**Response to the request for review for the CDM project activity
"Henan Zhengzhou Grid Connected Natural Gas Combined Cycle Power
Plant" (Ref. no. 1304)**

2007-12-30

Figure 1: Change in Installed Capacity of the Central China Grid (2002 – 2005)

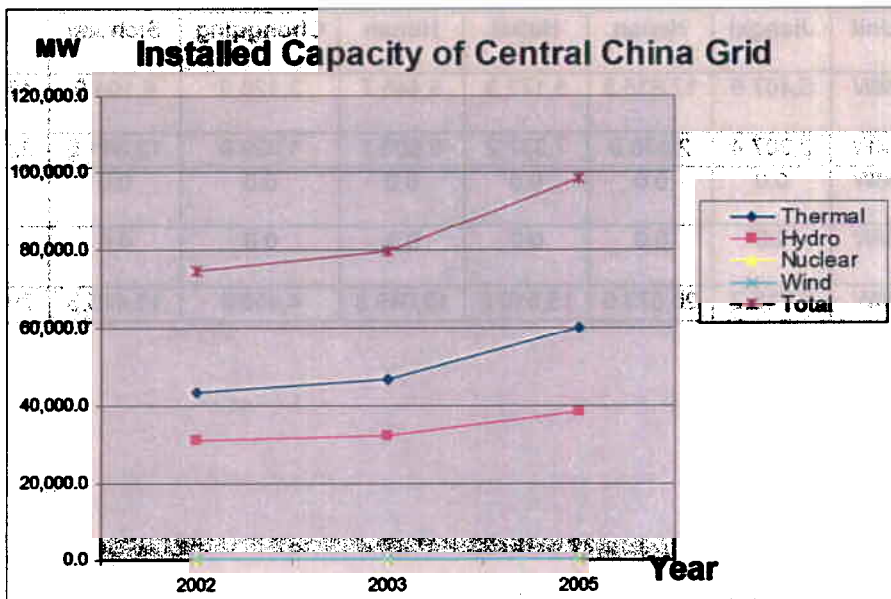
Further clarification is required on whether all relevant power plant technologies that have recently been constructed or are under construction or are being planned, including those of other investors, were considered as additional baseline scenarios.

According to the China Electric Power Yearbooks 2004-2006⁵, the increases in relevant plant technologies in the Central China Grid during 2002 to 2005 are presented under Tables 2 to 5 and Figure 1. This is used as indications of relevant power plant technologies that have recently been constructed, and include increases in capacities in thermal power, hydropower, nuclear power, wind power and others. It is also found that the increase in the thermal power capacity has substantially out-weighted other types of power during the mentioned period. The validation team confirms that these reported power plant technologies have been appropriately considered during the selection of baseline and presented in the PDD.
